**Public Input No. 3085, Assigned to Code-Making
Panel 1, Refer to Code-Making Panels 2 - 18**

Public Input No. 3085-NFPA 70-2023 [Global Input]

This Global Public Input is for all Technical Committees and review their informational notes and the requirements in the NEC Style Manual Section 2.1.10 for informational notes.

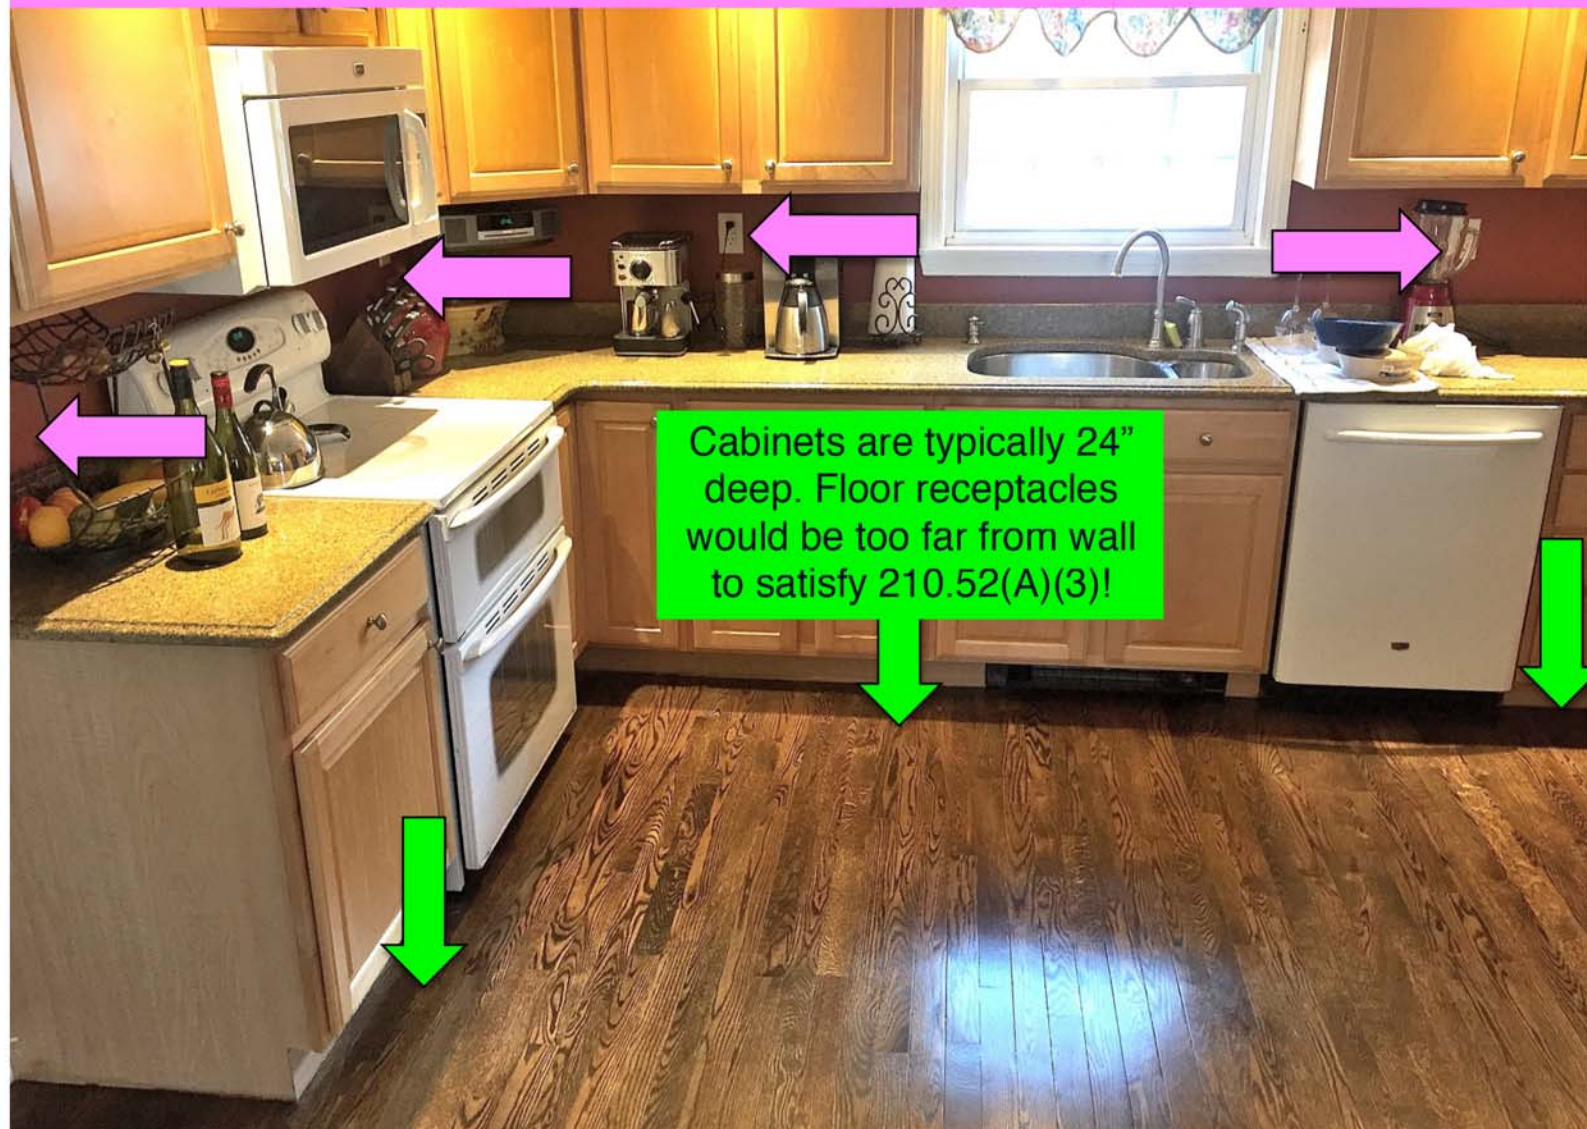
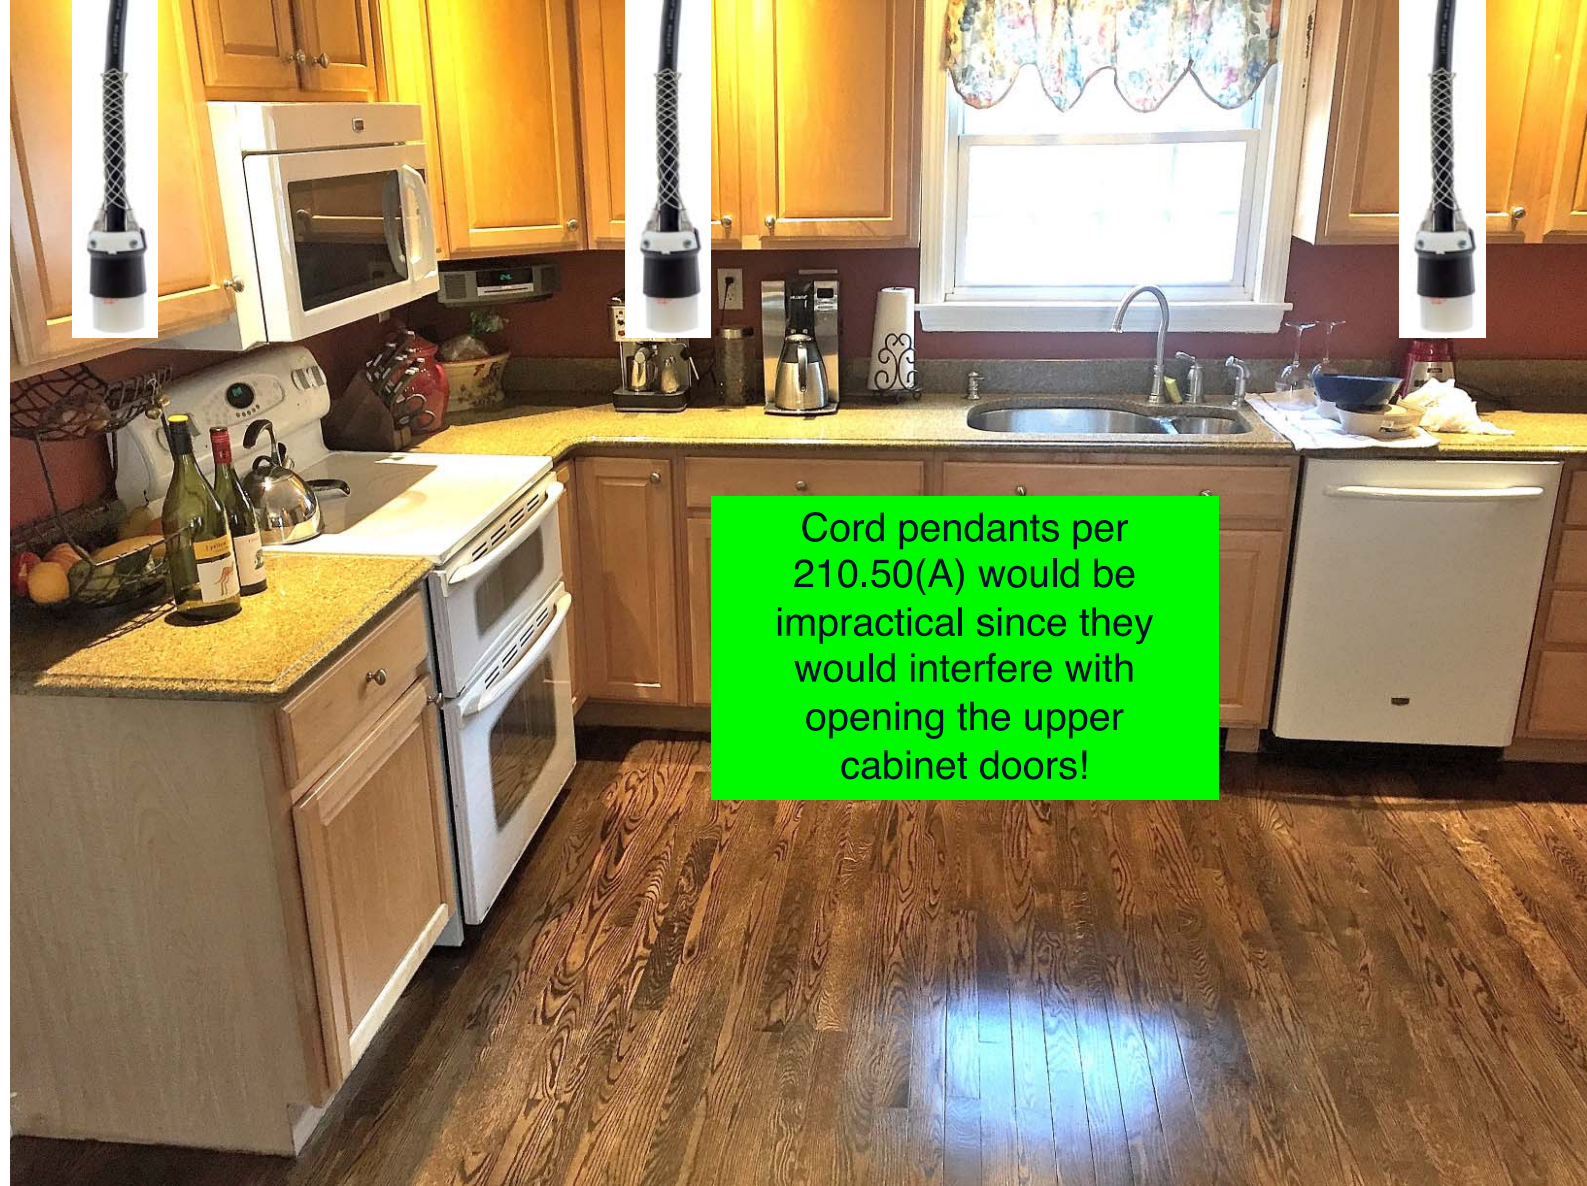
These receptacles cannot be used to satisfy 210.52(A) requirements!

But, according to 210.52(A)(4) and 210.52(C), Receptacles installed for countertop and similar work surfaces SHALL NOT be considered as the wall space receptacle outlets required by 210.52(A)

These receptacles cannot be used to satisfy 210.52(A) requirements!

These receptacles cannot be used to satisfy 210.52(A) requirements!
